## CALIFORNIA ENERGY COMMISSION

NOTIFICATION OF APPROVAL  
OF STANDARD U-FACTOR DATA  
FOR WOOD FRAMED ATTIC ROOFS  
WITH INSULATION  
ONLY BETWEEN THE CEILING JOISTS

This Notification of Approval of Standard U-factor Data, for Wood-Framed Attic Roofs With Insulation Only Between the Ceiling Joists, authorizes the use of the data shown in the attached Table IV.1c, including the limitations in the description following the table. Table IV.1c is now officially added as an addendum to Joint Appendix IV to replace the existing Table IV.1 and Table IV.1a.

*Figure IV.1c – Wood Framed Attic Roofs with insulation between the ceiling joists and does not cover the ceiling Joists*

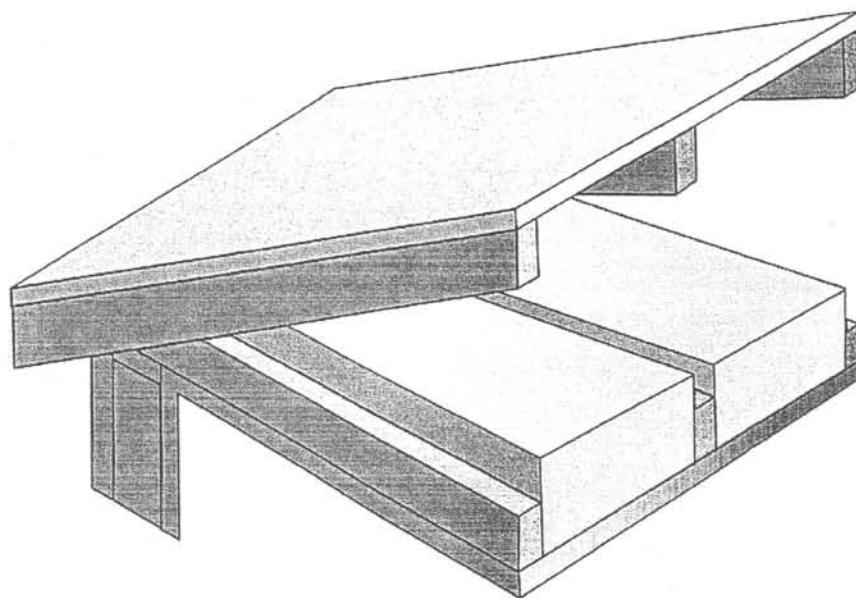
Table IV.1c shall be used only when insulation is placed between the ceiling joists of wood framed attic roofs. If insulation is placed over and completely covers the ceiling joists, then Joint Appendices IV, Table IV.1b shall be used. This table replaces the existing Table IV.1 and Table IV.1a. This table contains thermal performance data (U-factors) for wood framed attics where the ceiling provides the air barrier and the attic is ventilated. This table shall not be used for cases where insulation is located at the underside of the roof. Wood trusses are the most common construction for low-rise residential buildings and for Type V nonresidential buildings. While the sketch shows a truss system with a flat ceiling, the data in this table must be used for scissor trusses and other non-flat trusses. If the bottom of the ceiling is not flat, then the slope shall not exceed 4:12 if blown insulation is used. This table may also be used with composite trusses that have a wood top and bottom joist and metal struts connecting them.

For the majority of cases, values will be selected from column A of this table. Column A shall be used for the common situation where insulation is placed directly over the ceiling (and tapered at the edges) between, but not completely covering, the ceiling joists. Builders or designers may increase thermal

When this table is used, the R-value of continuous insulation shall be equal to or greater than the R-value published in the continuous insulation columns (columns B through H). For example, if the insulation is R-3, the R-2 column shall be used. No interpolation is permitted when data from the table is selected. The California Energy Commission approved ACMs, including those used for prescriptive compliance, may be used to accurately account for any amount of continuous insulation, or for unusual construction assemblies using Equation IV-1 and Equation IV-2.

**Assumptions.** The data from Table IV.1c are calculated using the parallel path method documented in the 2001 ASHRAE Fundamentals. These calculations assume an exterior air film of R-0.17, asphalt shingles of R-0.44 (AR02), building paper of R-0.06 (BP01), 1/2" of plywood of R-0.63 (PW03), an attic air space (greater than 3.5") with a R-0.80, 1/2" gypsum board (GP01) of R-0.45, and an interior air film (heat flow up) of R-0.61. Wood 2x4 framing is assumed at the ceiling level. Batt insulation is assumed between the framing members and no insulation over the framing. The framing percentage is assumed to be 10% for 16 in. OC and 7% for 24 in. OC. 7.25% of the attic insulation above the framing members is assumed to be at half depth, due to decreased depth of insulation at the eaves.
